APPLICATION NO.	FILING DATE	FIRST NAMED INVENTOR	ATTORNEY DOCKET NO.	CONFIRMATION NO.
09/876,396	06/07/2001	Syuichi Kariyazaki	14701	7345
23389 7590 07/27/2011 SCULLY SCOTT MURPHY & PRESSER, PC 400 GARDEN CITY PLAZA SUITE 300 GARDEN CITY, NY 11530				
EXAMINER MATTHEWS, COLLEEN ANN				
ART UNIT 2811		PAPER NUMBER		
MAIL DATE 07/27/2011		DELIVERY MODE PAPER

Office Action Summary**Application No.**

DETAILED ACTION

Annotated Figure 14

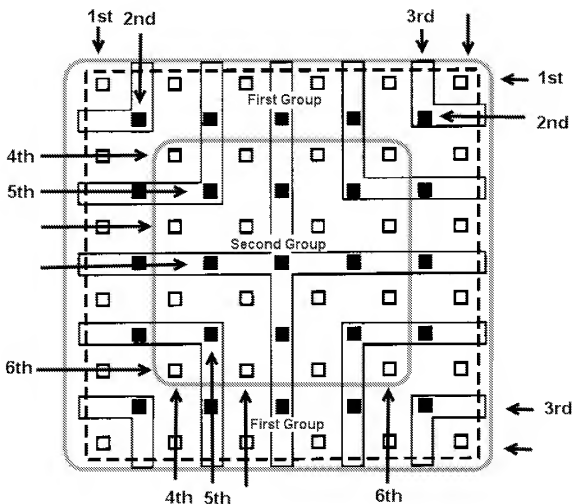
the interconnect pads forming a plurality of I/O cells including signal terminals, a portion of the I/O cells forming a first group (see annotated Fig 14, "+Shape (plus)", for example- first group considered as the outer area of pads labeled "First Group" Please note this is one sample presentation of the interpretation and others that read on the claim language are possible as well.) of I/O cells and another portion of the I/O cells forming a second group (see annotated Fig 14 "+Shape (plus)", for example- second group considered as inner area of pads labeled as "Second Group" Please note this is

the first group of I/O cells including a first row, a second row, a third row, a first column, a second column and a third column of interconnect pads (see annotated Figure 14, this example interpretation includes 4 rows and 4 columns, showing specifically an example of what could be considered as 1st, 2nd, and 3rd rows as well as the 1st, 2nd, and 3rd columns. Please note this is one sample presentation of the interpretation and other interpretations that read on the claim language are possible as well.) disposed to encircle a center of the mounting member, and

the second group of I/O cells including a fourth row, a fifth row, a sixth row, a fourth column, a fifth column and a sixth column of interconnect pads (see annotated Figure 14, this example interpretation has 7 rows and 7 columns, showing specifically an example of what could be considered as 4th, 5th, and 6th rows as well as 4th, 5th, and 6th columns. Please note this is one sample presentation of the interpretation and others that read on the claim language are possible as well) disposed to encircle a center of the mounting member (also col 11 lies 48—col 12 line 40),

the first group of I/O cells arranged in the first row, the first column perpendicular to the first row (see annotated Fig 14), the second row disposed on an inner position relative to the first row, and the second column that is perpendicular to the second row

and disposed on an inner position relative to the first column (see annotated Fig 14, arrows indicate second rows and columns inner to first rows and columns)

the second group of I/O cells arranged in the fourth row, the fourth column perpendicular to the fourth row (see annotated Fig 14), the fifth row disposed on an inner position relative to the fourth row, and the fifth column that is perpendicular to the fifth row and disposed on an inner position relative to the fourth column (see annotated Fig 14, arrows indicate fifth rows and columns inner to fourth rows and columns);

the first row, the second row, and the third row of the first group of I/O cells are parallel to one side of the semiconductor member (see annotated Fig 14),

the first column, the second column, and the third column of the first group of I/O cells are parallel to an another side of the semiconductor member(see annotated Fig 14),

the fourth row, the fifth row, mad the sixth row of the second group of I/O cells are parallel to the one side of the semiconductor member (see annotated Fig 14),

and the fourth column, the fifth column, and the sixth column of the second group of I/O cells are parallel to the another side of the semiconductor member (see annotated Fig 14)

Regarding claim 10, Moresco discloses a semiconductor device, wherein at least one of the first group (see annotated Fig 14- first group) and the second group (see annotated Fig 14- second group) includes an outer group (see annotated Fig 14-

first group) and inner group (see annotated Fig 14-second group) disposed on the inner position of the mounting member with respect to the outer group (see annotated Fig. 14-first group).

In response, the Examiner disagrees. Each of Moresco's rows are arranged parallel to a side of the mounting member and each of Moresco's columns are arranged parallel to a side of the mounting member and all of the rows and columns surround the center of the mounting member.
